TO: Mercedes-Benz Dealer Principals, General Managers, Sales Managers, Service Managers, Parts Managers	FROM: Gregory Gunther, Senior Manager, Vehicle Compliance and Analysis, Engineering Services
RE: Recall Campaign Initial Notification Replace Transmission Wiring Harness – Amendment 2 MY19-25 E-Class, CLS and AMG GT 4-Door (213, 238, 257, and 290)	DATE: October 25, 2024

Recall Campaign Initial Notification			October 25, 2024
Campaign No. :	NHTSA ID	Campaign Desc. :	Replace Transmission Wiring Harness – Amendment 2
TBA	24V445	24P2195422	
<p>This is to notify you of the new Recall Campaign to replace a certain transmission wiring harness on 22,422 Model Year (“MY”) 2019-2025 E-Class, CLS, and AMG GT 4-Door (213, 238, 257, and 290 platform) vehicles. The recall campaign will be visible on the www.NHTSA.gov website and may generate questions from customers. 16,967 affected VINs were flagged in VMI as “PENDING” on June 24, 2024. An additional 32 affected VINs were flagged in VMI as “PENDING” on August 16, 2024. An additional 5,423 affected VINs will be flagged in VMI as “PENDING” on October 25, 2024.</p>			
Background			
Issue	Mercedes-Benz AG, the manufacturer of Mercedes-Benz vehic

Figure 1

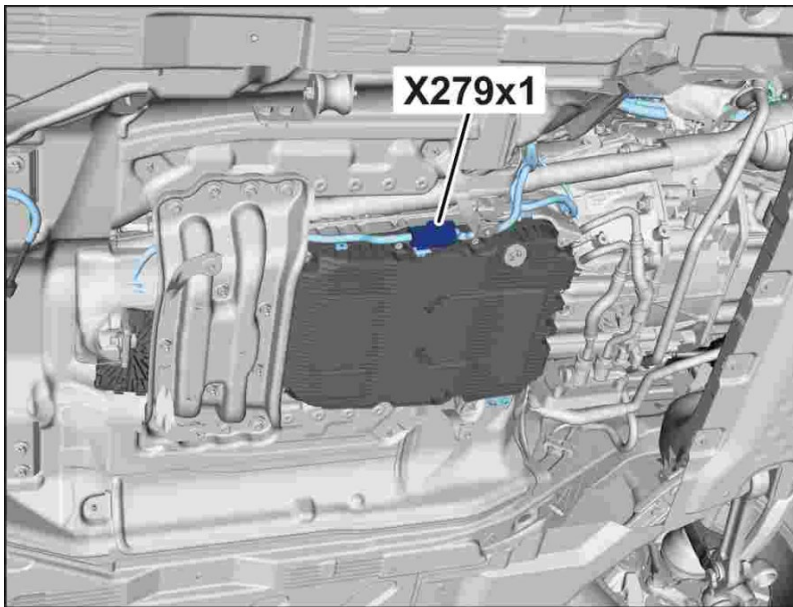
1. Immediately disconnect electrical connector **X279x1** (Figure 1) for the **All-Wheel Drive Control unit N45**.

2. Park the vehicle outside. **End Measure.**
